Village Green Enhancements, Thredbo Village Modification 2

Modification Application Assessment (MOD 24/14675 (DA 6877 MOD 2))

June 2025

Published by the NSW Department of Planning, Housing and Infrastructure

Figure 3 | Proposed Nature Play Playground Design (Source: Applicant's documentation)

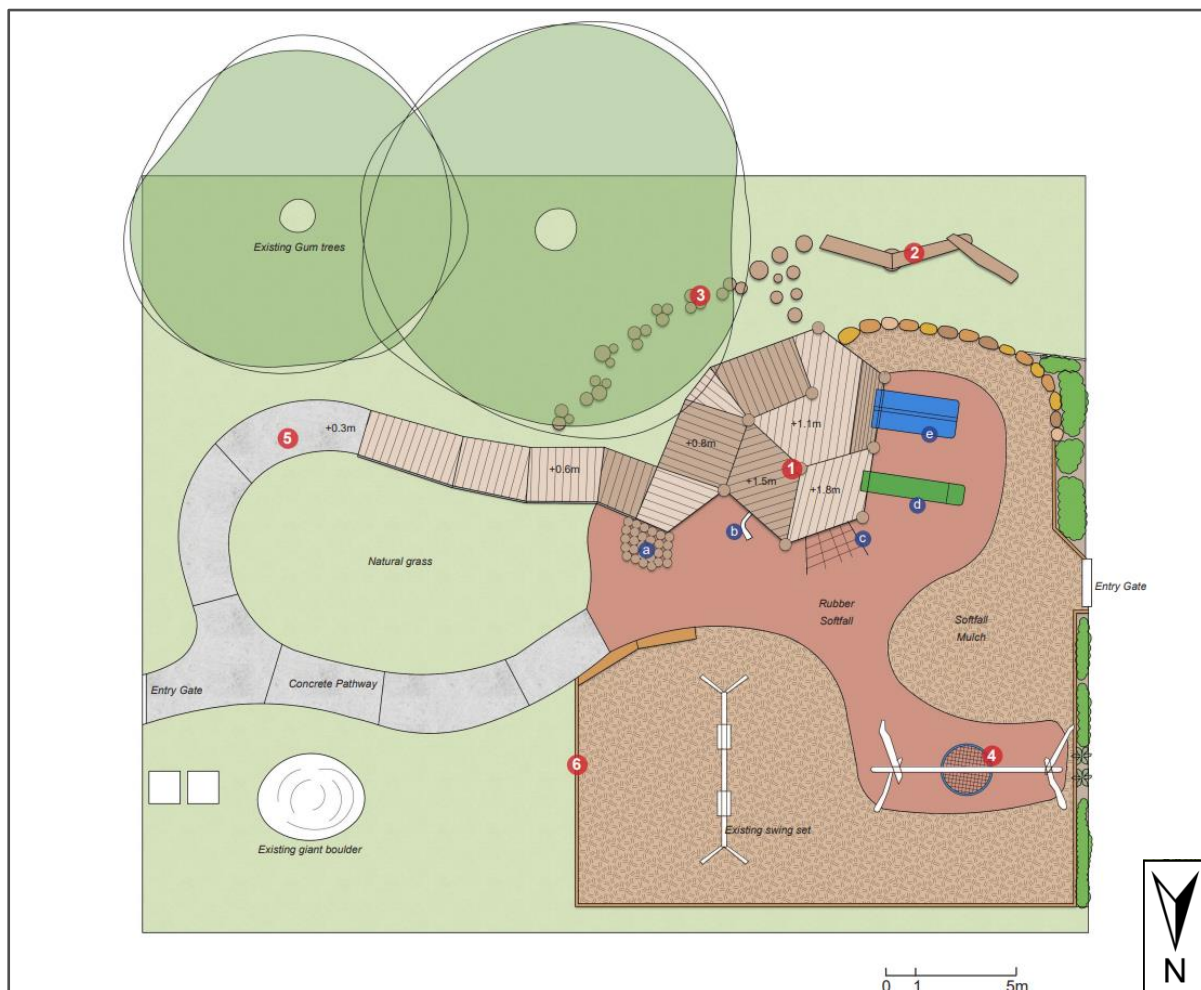
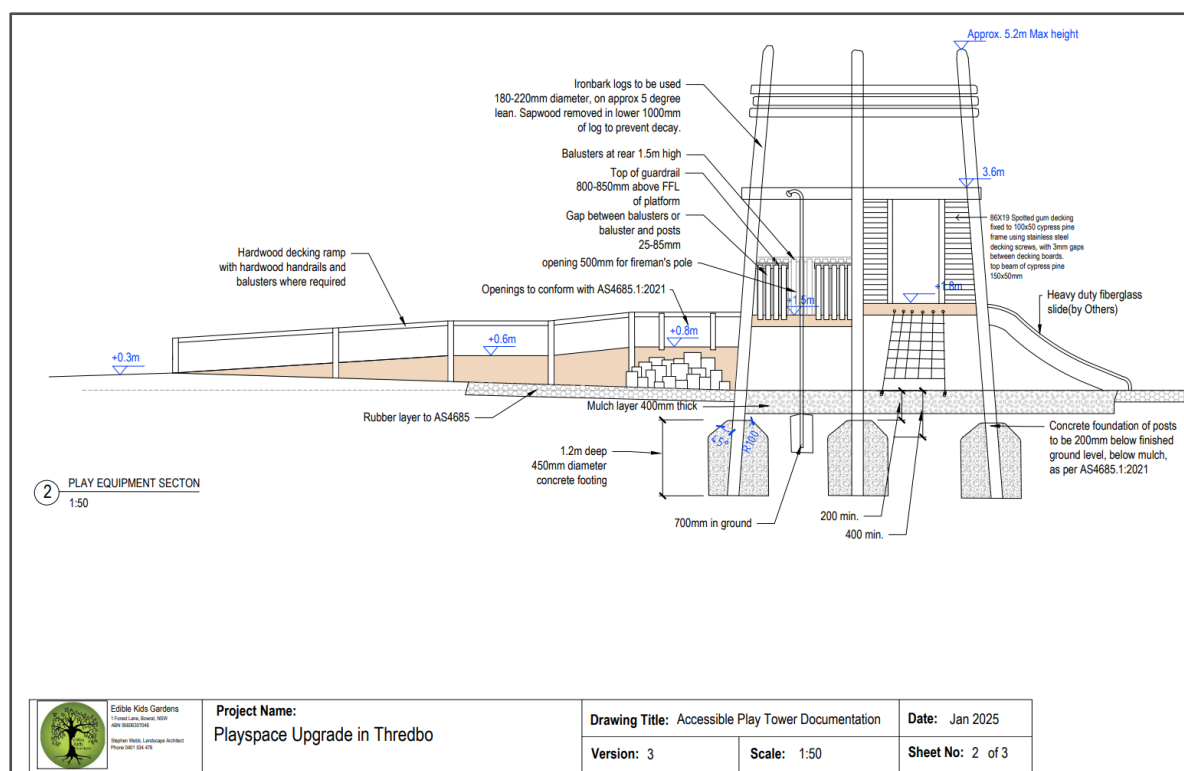
The Department raised concerns around the design details for the playground, specifically regarding the replacement of the street furniture, and the height of the ironbark logs. Additionally, concerns were raised around the specifications of the playground fence (such as the materials, colours, heights and footing detail) weren't specified within the reports received by the Department. The Applicant responded to the Department's concerns, confirming the ironbark logs are estimated to have a maximum height of 5.2 m, and stating the street furniture will be removed from the playground. The applicant also responded to the specifications of the new playground fence, stating it will be a like for like replacement with the addition that the height, and setback of the southern side of the fence footprint will be increased to avoid tree enrichment.

Figure 6 | Pavement Plan Rev B (Source: Applicant's documentation)

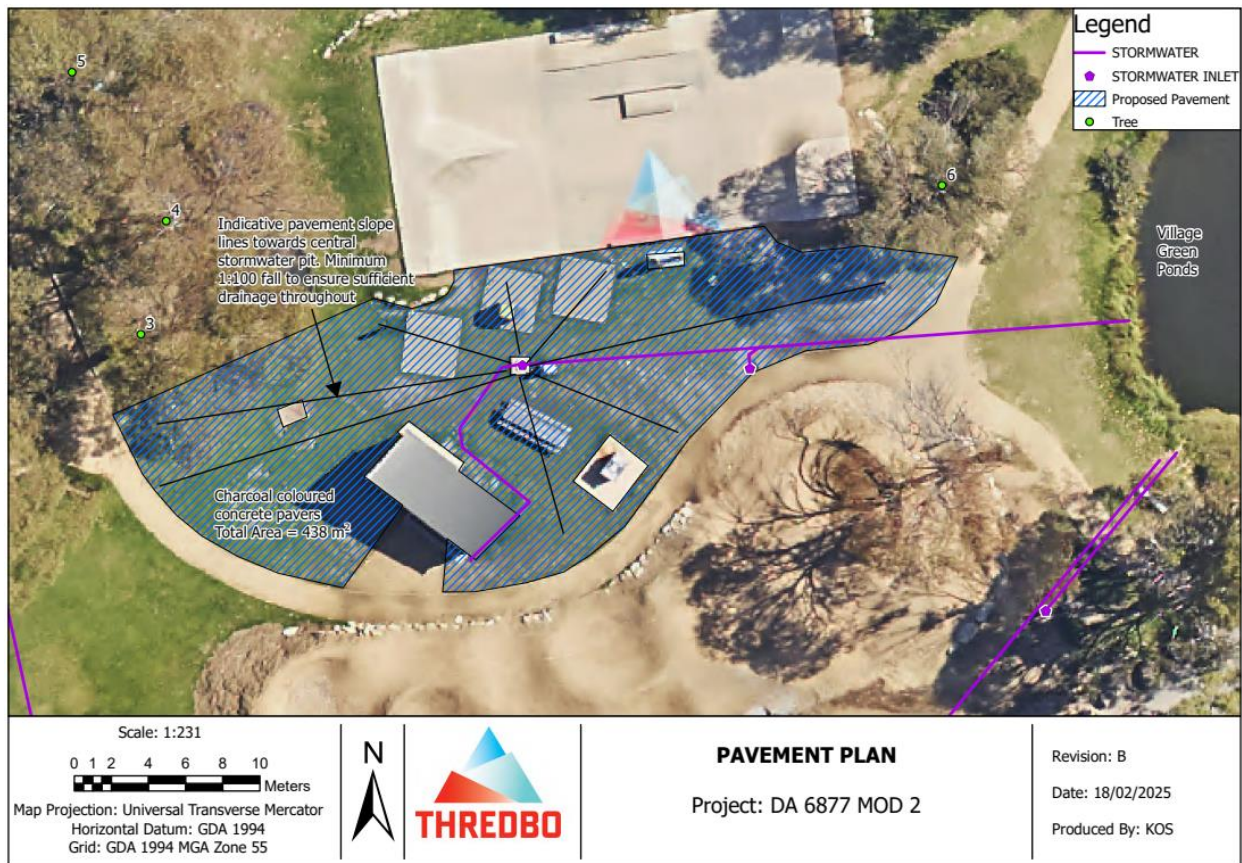
The Department raised concerns around the details of the redevelopment of the plaza area, requesting more information around the extent of the boundaries of the paving proposed, colours, materials, gradients used to facilitate drainage and tree zones around nearby trees. The applicant responded to this inquiry by submitting a Pavement Plan outlining the specifications of the area, slope lines / shallow levelling, and stormwater inlets points connecting to water infrastructure.

Figure 8 | Pump track and emergency access track (Source: Applicant's SEE)

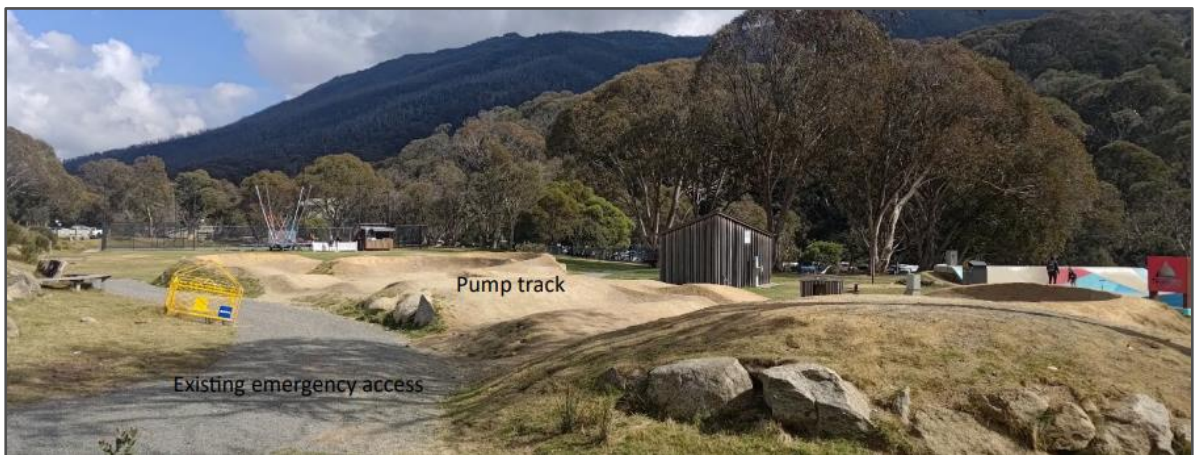
The Department raised concerns with the proposal for the emergency access track, noting the absence of a section plan containing specifications of the measurements and related designs including the drainage, gates, bollards. Additionally, the department requested more information around the design and engineering of the boulder gravity retaining wall.

The Applicant responded to the Department's concerns, stating that the track disturbance will be approximately 4m wide with a slightly larger footprint to allow for construction - the applicant stated no

updates to the site plan were required. Individual boulders for the gravity retaining wall will be placed along the edge of the track similar to the existing boulder gravity wall lining the edge of Thyne Reid Drive.

Figure 11 | Water Main Alignment (Source: Applicant's documentation)

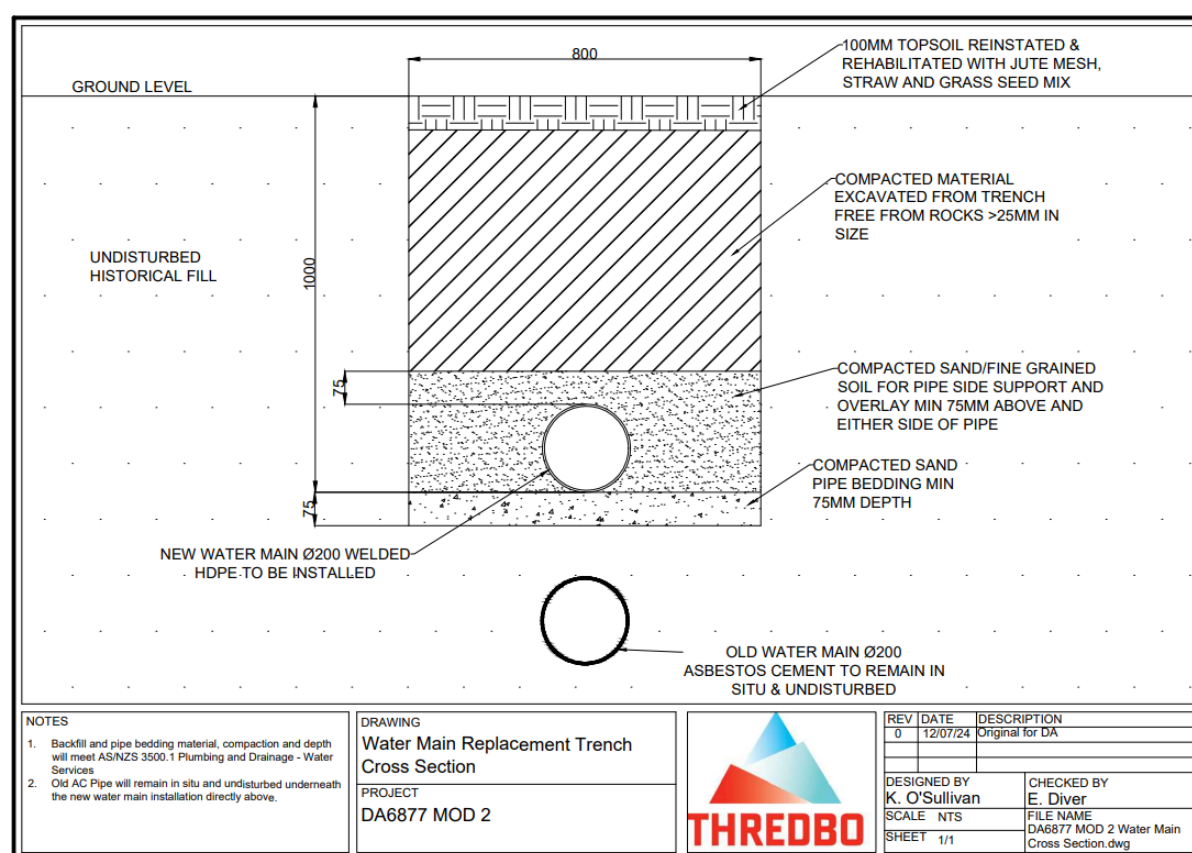
As discussed in **Section 2.4**, the Applicant proposes to modify the consent to the replace the water main infrastructure. The applicant proposed to leave the existing AC (asbestos cement) water main in situ (1.8m below ground level) while installing the new water main infrastructure 800mm above the existing water main (1m below ground level). In the event of any Safework NSW Asbestos Removal Guidelines will be followed, and the asbestos removed offsite to a Licenced Waste Facility as per NSW EPA's Integrates Waste Tracking Solution (IWTS).

The application was referred to the Department's Building Surveyor who raised no concerns regarding the application. Conditions of consent have been recommended for demolition, earthworks, excavation around the instillation of watermain infrastructure.
